FF-L-2937
AMENDMENT 1
May 22, 2006

FEDERAL SPECIFICATION

COMBINATION LOCK, MECHANICAL

The General Services Administration has authorized the use of this amendment, which forms a part of FF-L-2937, dated January 31, 2005, by all federal agencies.

Figure 4

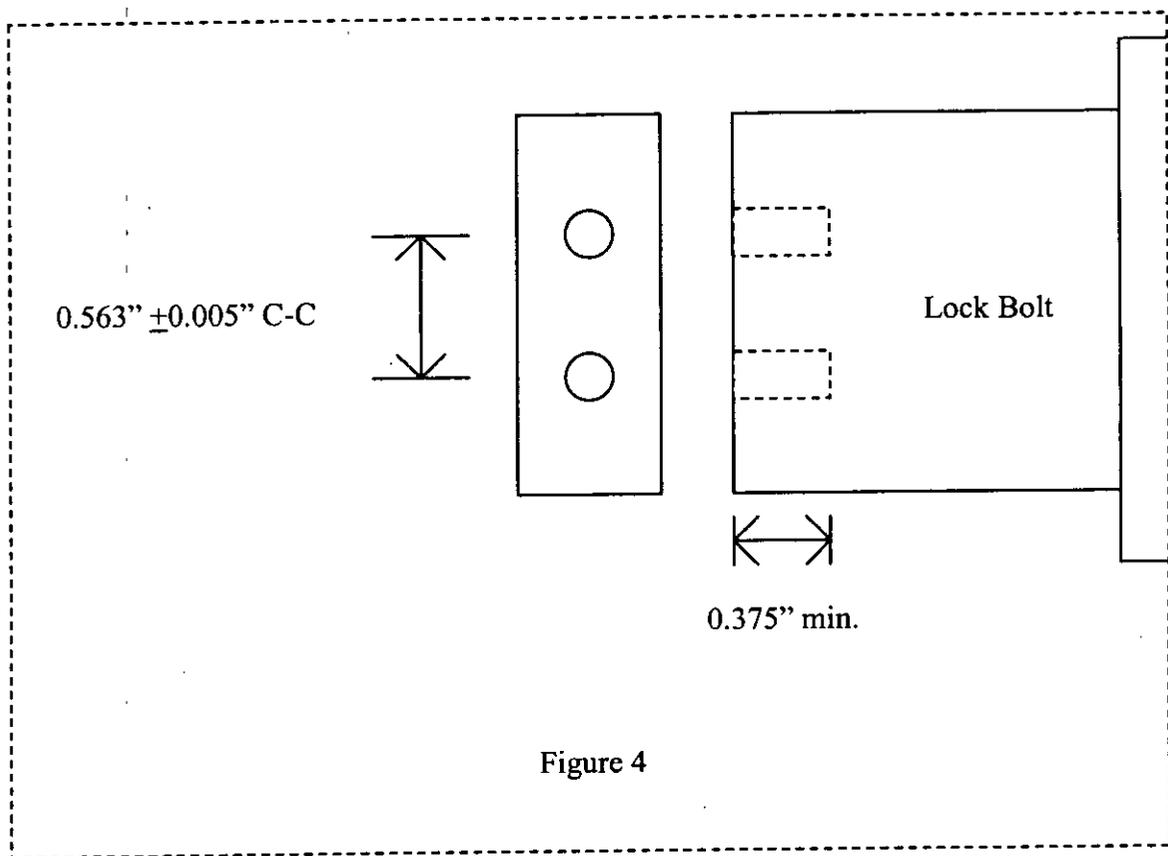
3.13.2 Bolt Design. The locking bolt shall have two threaded holes in the end of the bolt. The holes shall be #10-32 UNF with a center to center distance of 0.563 ± 0.005 inch. The holes shall be tapped to a minimum depth of 0.375 inch (see figure 4).

Add the following Figure to the end of the document:
